## PRODUCT CHANGE NOTIFICATION

PCN-DCT-SEMS-11

Business Unit	Product Line Code	Type of Change	Action	Date of issue
DCT	200	Mechanical	Notify Distributors and Field	05/19/2011

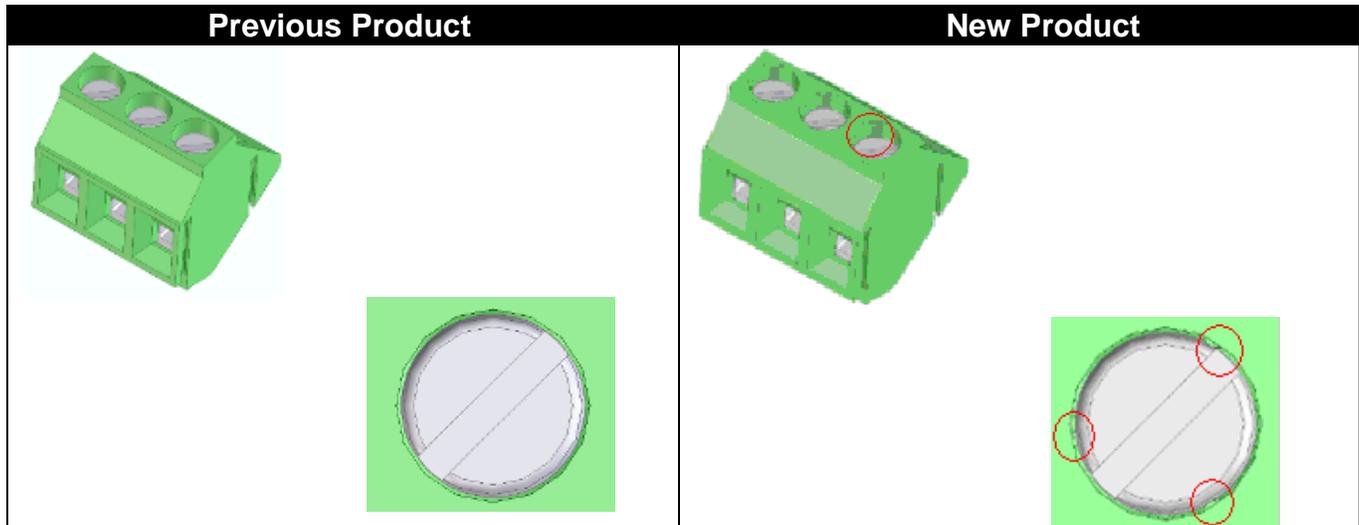
Due to our continuous improvement process the mentioned parts will be delivered with an additional screw brake. Three plastic fins are inserted in the screw shaft to prevent the closing of the clamping space during transportation. Dimensions and technical data remain the same. During the conversion period both versions will be delivered depending on the inventory.
